ADDENDUM NUMBER FOUR

**DISTRICT FIVE OF
LEXINGTON & RICHLAND COUNTIES
CHAPIN ELEMENTARY SCHOOL**

**CALLOWAY JOHNSON MOORE WEST (CJMW)
201 WEST MAIN STREET
LEXINGTON, SOUTH CAROLINA 29072**

DATE OF ISSUE: April 9, 2009

DRAWING C9
DETAIL FOR INSTALLATION OF
MATTING ON SLOPES

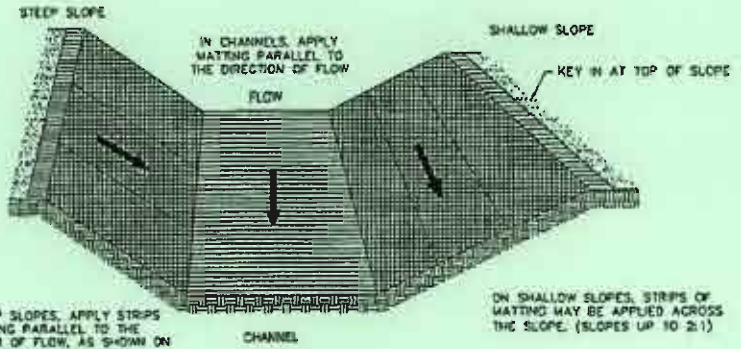
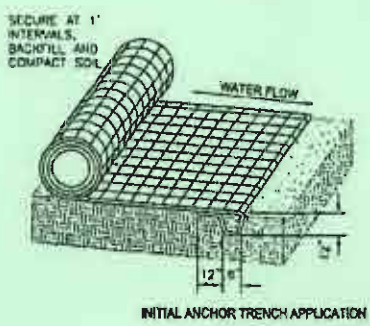
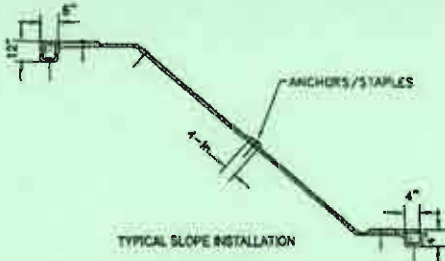
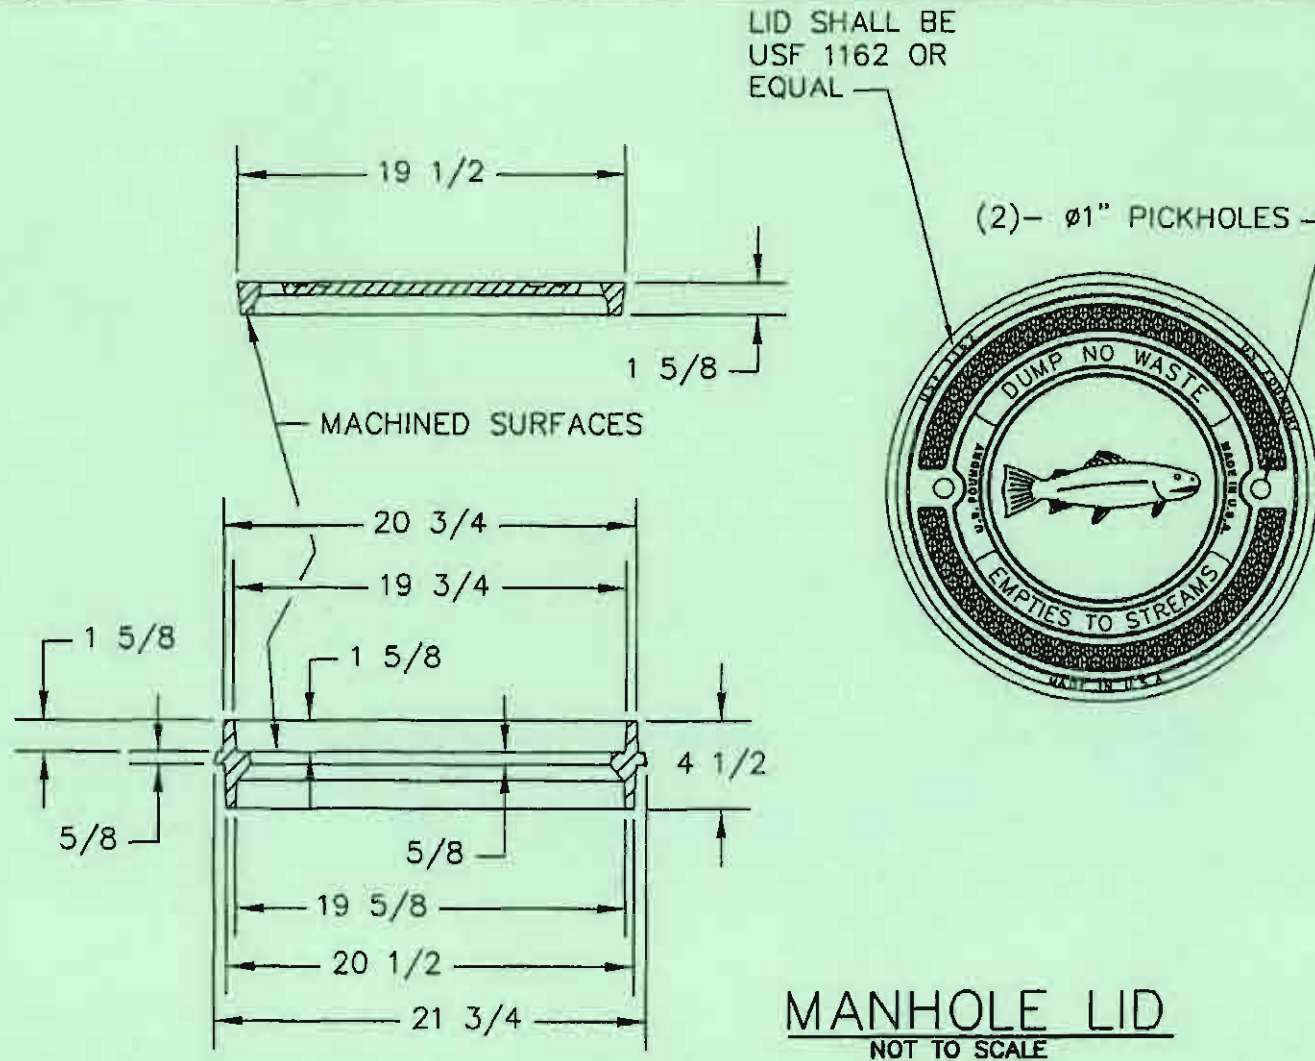
16. **Drawing Sheet C9:**
Add the detail for installation of matting on slopes as shown in the (see attached Sketch BDC007).
17. **Drawing Sheets D101, D102:**
Clarification: General contractor is responsible for removing and disposing of existing demountable partitions unless Owner wants them (first right of refusal similar to equipment note).

BDA001 Sheet of

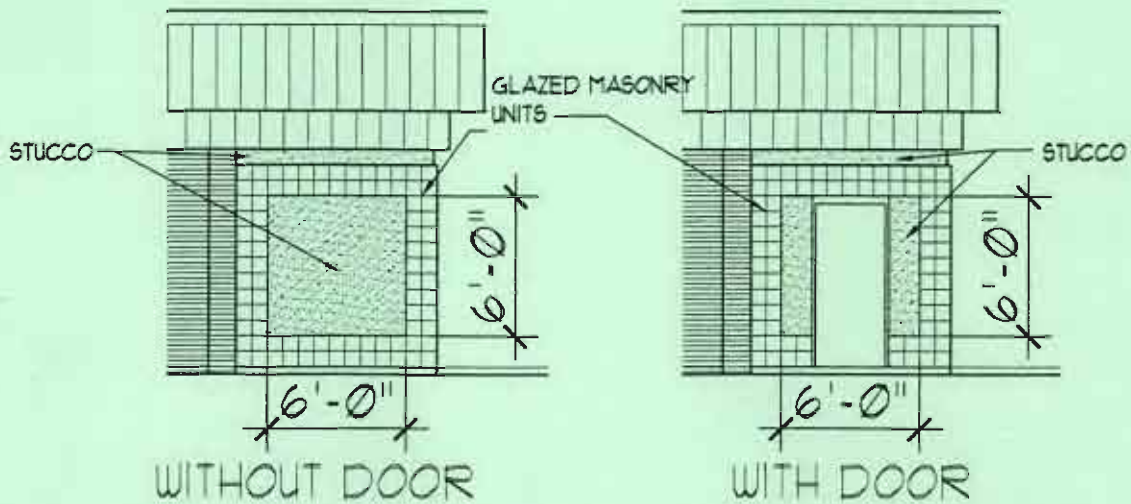
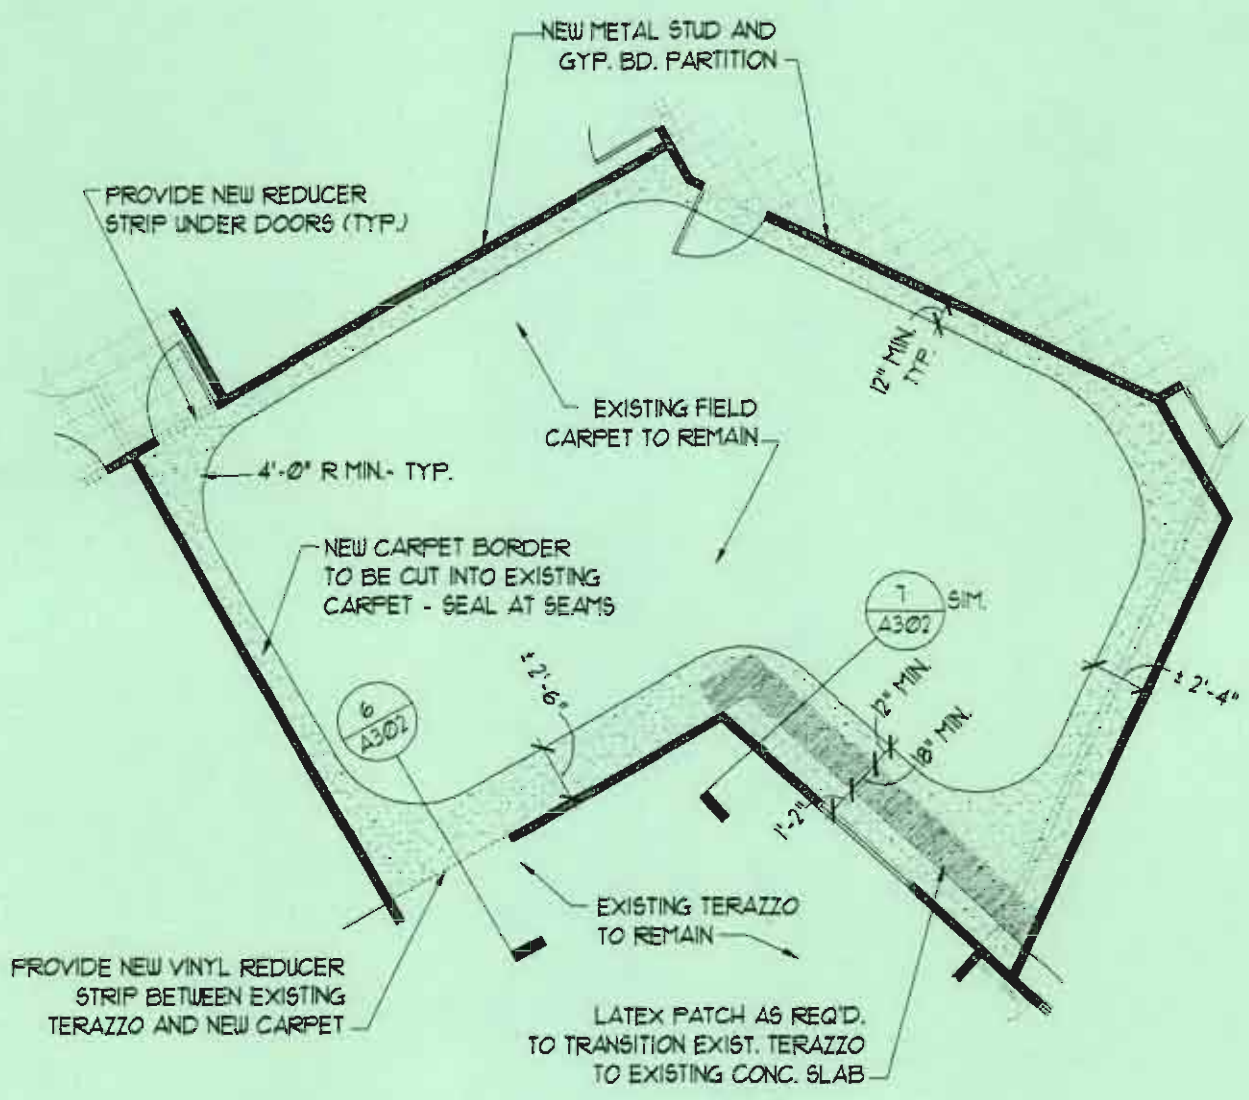
19. **Drawing Sheet A206: Kindergarten Addition:**
For clarification on the three exterior walls of Kindergarten Storage Rooms E104, E110, E114, E118, E120, E126, and E132, and exterior walls of Kindergarten Storage Room E128 Add attached Enlarged Plan – Typical Kindergarten Stg. Room - See (Attachment BDA001).

26. **Drawing Sheet A501: Exterior Elevations:**
For clarification on the three exterior walls of Kindergarten Storage Rooms E104, E110, E114, E118, E120, E126, E132, and E128- Add Typical Kindergarten Storage Room Elevations (Attachment BDA001).

FLOOR FINISH PATTERN PLAN - A112A & B107A
 SCALE: 1/8" = 1'-0" (A107A & B114A - OPPOSITE)

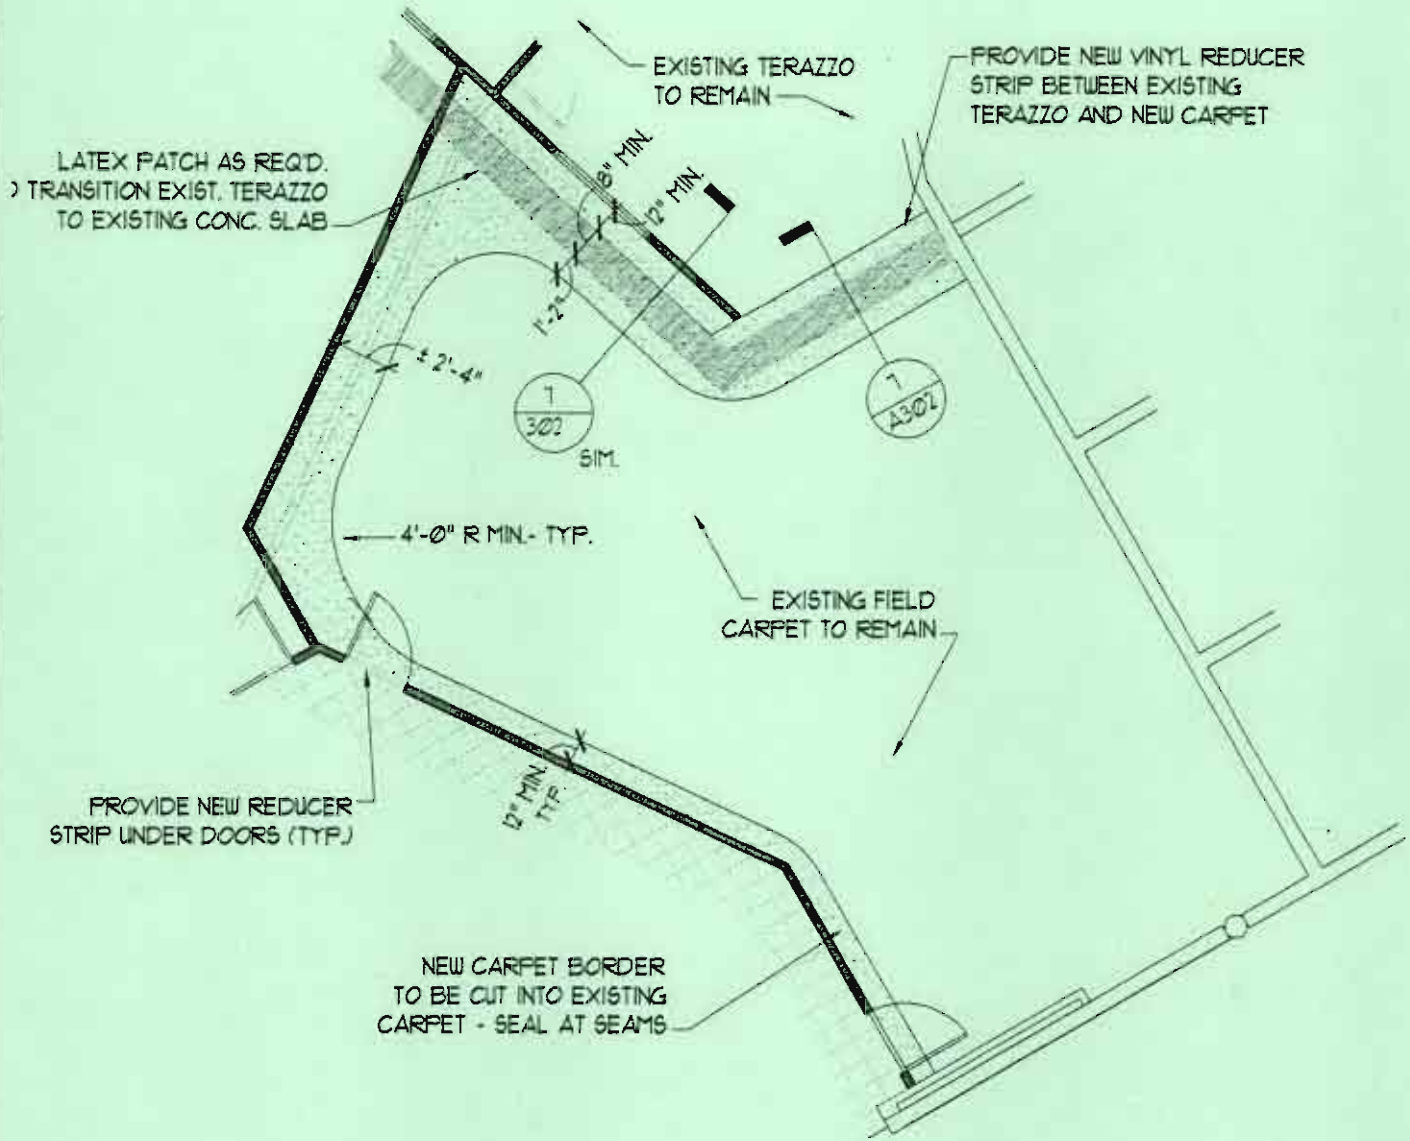
24. **Drawing Sheet A302 – Floor Finish Pattern Plan:**
Add the two enlarged plans to this sheet as attached on BDA002, and BDA003.
25. **Drawing A401 – Enlarged Plans and Interior Elevations, 17/A401.**
Typical Large Scale Plan 17/A401: Amend Toilet Accessory numbers TA2 near lavatories to be TA4. These are paper towel holders, not toilet tissue dispensers.

PARTIAL ROOF FRAMING PLAN

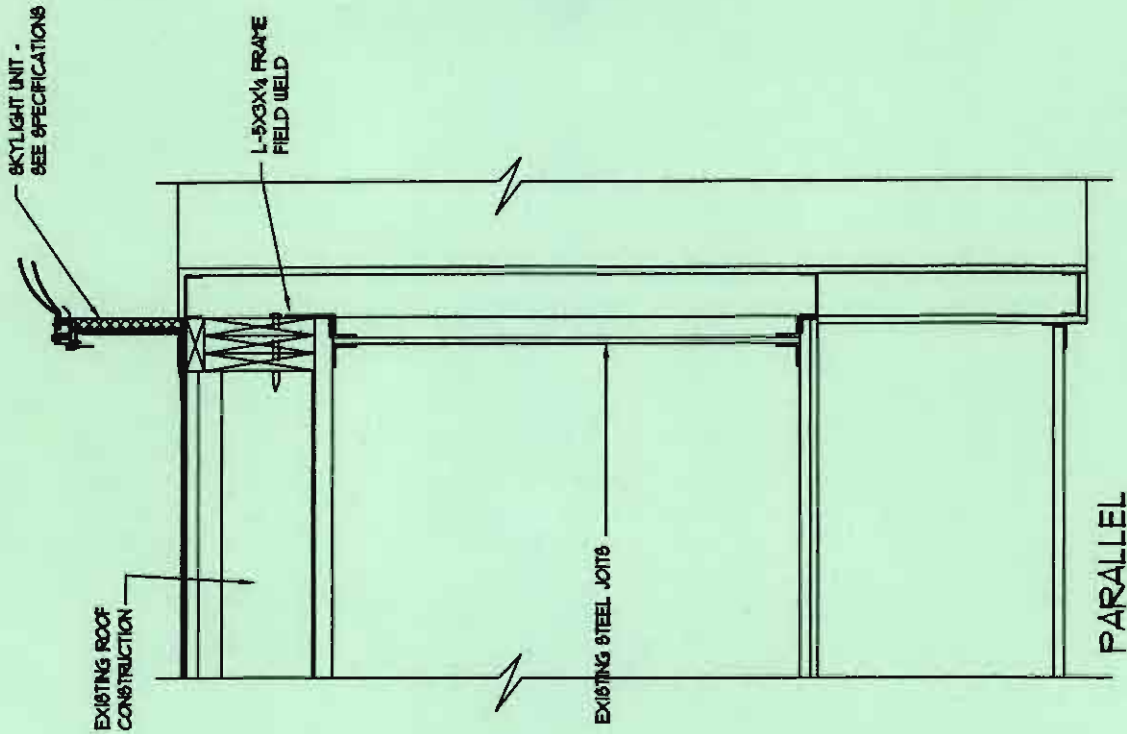
Detail – Areas A and B Typical Skylight Detail – Perp. To Joists shall be amended from Detail 4/601 to 3a/A601.
30. **Drawing Sheet A803 Details 8,9,10, 12.**
Amend Note "4" Square Steel Tube Columns, See Structural" to "Round Steel Columns – See Structural"
31. **Drawing Sheet S201:**
See Revised Roof Framing Plan on attached Sketch BDS001.

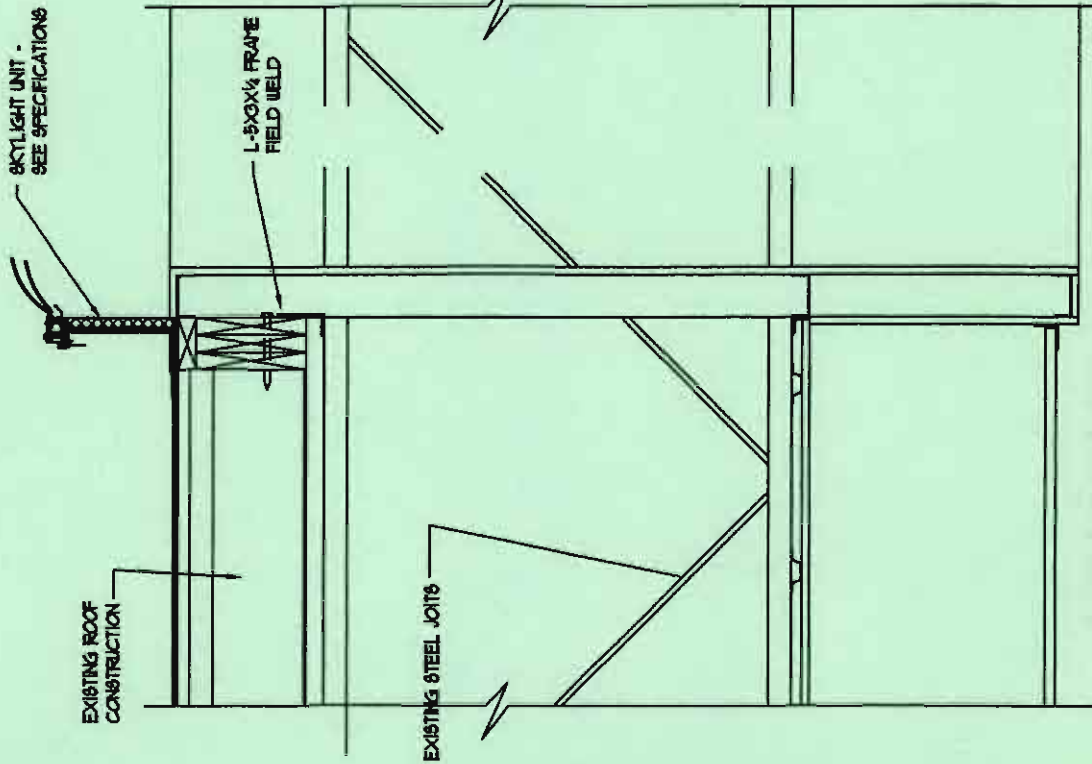
32. **Drawing Sheet S401:**
See the Skylight Framing Detail on **attached Sketch BDS002.**
33. **Drawing Sheet S401:**
See the Skylight Non Bearing CMU Wall Bracing Detail on **attached Sketch BDS003.**
34. **Drawing Sheet SP2:**
Refer to Arch drg, sht A201 for skylights being added in rooms A112A, B114A and B125A. Contractor shall provide horiz sidewall head for coverage at skylights as required. Piping to sidewall head shall rise concealed in stud furring with reducing 90 at top of rise. Coordinate with general contractor as required. (See skylight details sht A601)
35. **Drawing Sheet P3:**
Coordinate routing of 2" vent piping to Toilet A129 to prevent conflicts with exist gyp board ceilings. (Refer to Arch drgs, sht A208 as required)
36. **Drawing Sheet P7:**
Refer to Civil drgs, sht C4 and provide connection to 6" sanitary stub approx where indicated.
